**Number:** TIC2014-0008

**Title:** Variable Speed Heat Pump Fault Code 86 change to 62

**Product Category:** Air Conditioners/Heat Pumps

4-Pin Scroll & Motor NTC Thermistor Plug

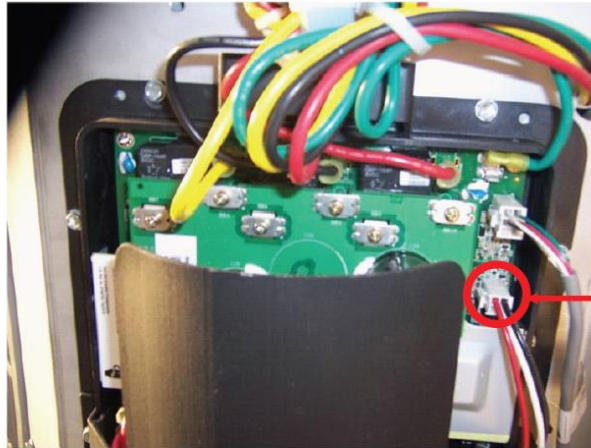
Version 19; *fault code 86 is for a "compressor temp sensor fault". This means that either the motor or scroll thermistor embedded in the compressor is defective, such as open or shorted. Troubleshoot the thermistor resistances at the inverter plug shown below.*

Remove This Plug

*If the readings show either an open or shorted, the compressor needs to be replaced.*
